SUBJECT: STALL WARNING SWITCH, CIRCUIT MODIFICATION

MODEL/S/N
AFFECTED: MOONEY M20J, S/N 24-3201, 24-3218 THRU 24-3257
MOONEY M20L, S/N 26-0001 THRU 26-0041
MOONEY M20M, S/N 27-0001 THRU 27-0134

REVISION A IS REQUIRED TO CORRECT SCHEMATICS (PAGE 2) FOR MODIFICATION.

FIGURE SI M20-91-1

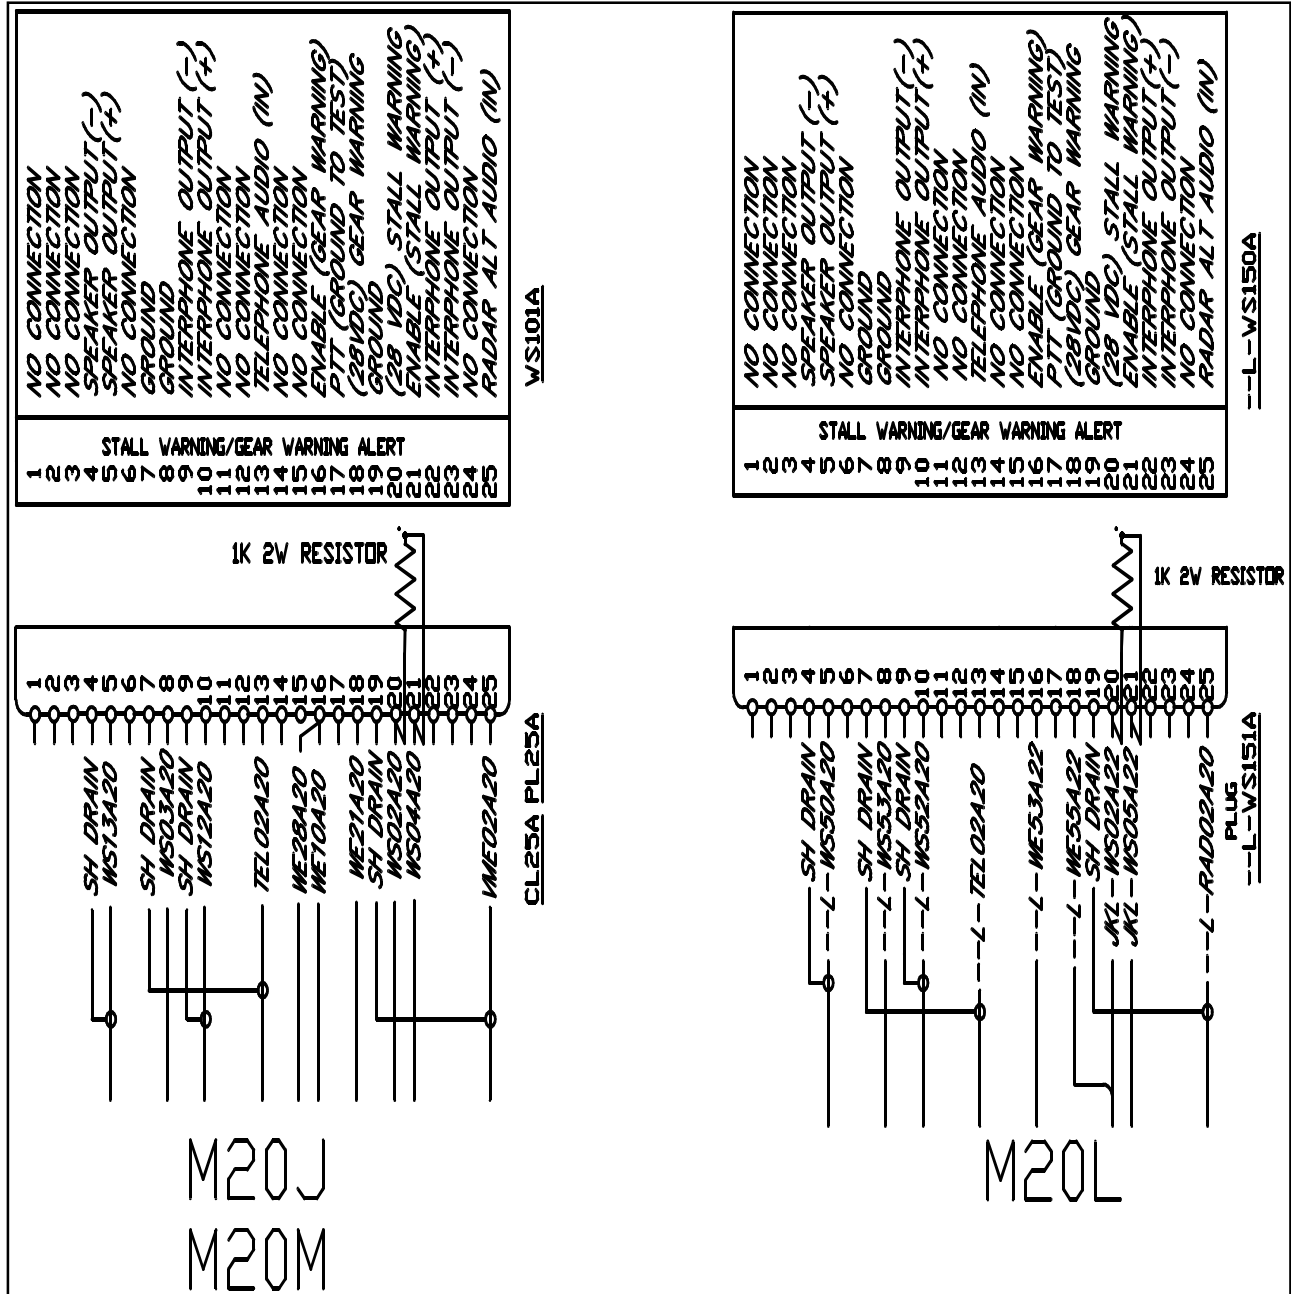
INTRODUCTION: THERE HAVE BEEN REPORTS THAT OPERATIONS IN PRECIPITATION MAY CAUSE THE STALL WARNING HORN TO ACTIVATE AT A REDUCED AUDIBLE SIGNAL WHILE THE AIRCRAFT IS IN LEVEL CRUISE FLIGHT. THIS CAN BE PREVENTED BY ADDING RESISTORS TO THE WIRING CIRCUITS PER THE INSTRUCTIONS BELOW.

3. Select the applicable schematic (M20J - M20L - M20M) shown in Figure SI-M91-1 and solder the MIL-R-11-RC42, 1K 2W resistor, (RC42-HB-102-J, included in kit) to the correct numbered connectors. The resistor must be positioned so it will not interfere with the connection of the wire harness back to the tone generator. Protect the resistor with heat shrink or other insulation.
